# Access Compliance Report

## Public Rights-of-Way

### (Curb Ramps)

Intersection ID: N/A	Main Street: FREEDOM_DR	Cross Street: S_I-85_RA	Location: W
ADA ID: 5A900AC13952	Ramp Type: BlendTrans1	Initial Pass/Fail: Pass	Overall Compliance: No
		Severity Score: 10

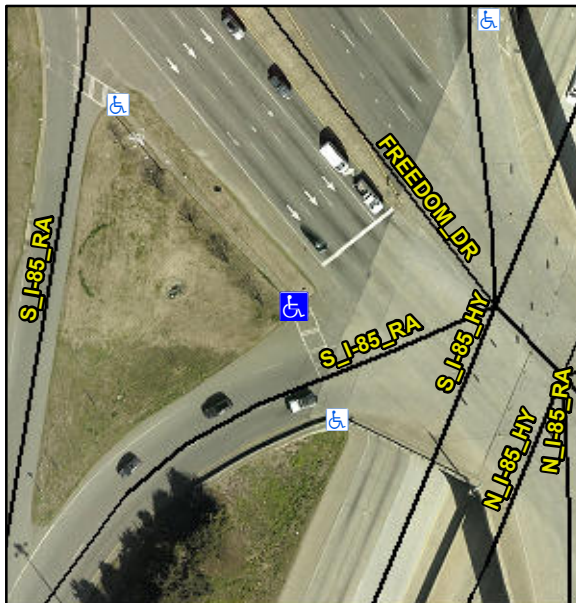
Surveyor Notes:

**LOCATED ON ISLAND**

PROW/ADA:

**R304.5.3, R305**

Possible Solutions:

**Remove & Replace Curb Ramp With Two New Directional Ramps or Equivalent.**
